# Fact Sheet for NPDES Permit WA002515-1

## Columbia Generating Station

### Appendix E--Response to Comments

Artist rendering – from ENW provided design documents:

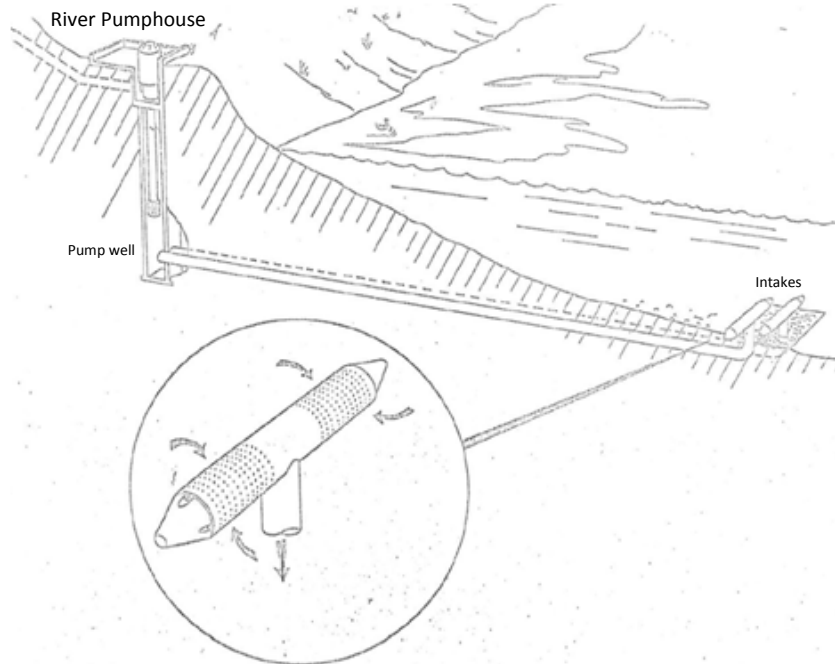
EFSEC failed to conduct its own, or require Energy Northwest to complete, any studies to support its BPJ determination. Outdated studies are not a reasonable basis for assessing the adverse environmental impact of the cooling water intake structures. EFSEC simply states that "[n]o adverse environmental impact has been demonstrated." See Fact Sheet at 25. This statement blatantly ignores EPA's comments noting that there have been no current studies to determine whether there is an adverse environmental impact. It is illogical to claim that something does not exist simply because no one has looked for it. EFSEC must consider the likely adverse environmental impacts, as identified by NOAA, along with the other factors when determining BPJ. By failing to rely on or require recent studies of impingement and entrainment

First, an overarching critic in the comments was a perceived lack of data used in EFSEC's analysis of Best Technology Available (BTA). To help remedy this, a fuller description of the existing intakes will be helpful. From the fact sheet:

CGS withdraws water from the Columbia River through two 42-inch diameter inlets perforated with 3/8 inch diameter holes, each approximately 20 feet long and placed parallel to river flow approximately 350 feet offshore at low water. Water flows by gravity to the River Pumphouse.

In evaluating Best Technology Available (BTA), EFSEC considered the design of the CGS intakes as compared to designs considered by EPA in development documents for 316(b) rules. In its comment letter on the draft permit, EPA specifically referred EFSEC to, *Development Document for Best Technology Available for the Location, Design, and Construction, and Capacity of Cooling Water Intake Structures for Minimizing Adverse Environmental Impacts* (EPA, 1976). This document discusses various technologies including “fixed screens” which best fit the technology employed at CGS. It notes that fixed screen installations vary greatly, with effectiveness dependent on site specific design. It also notes:
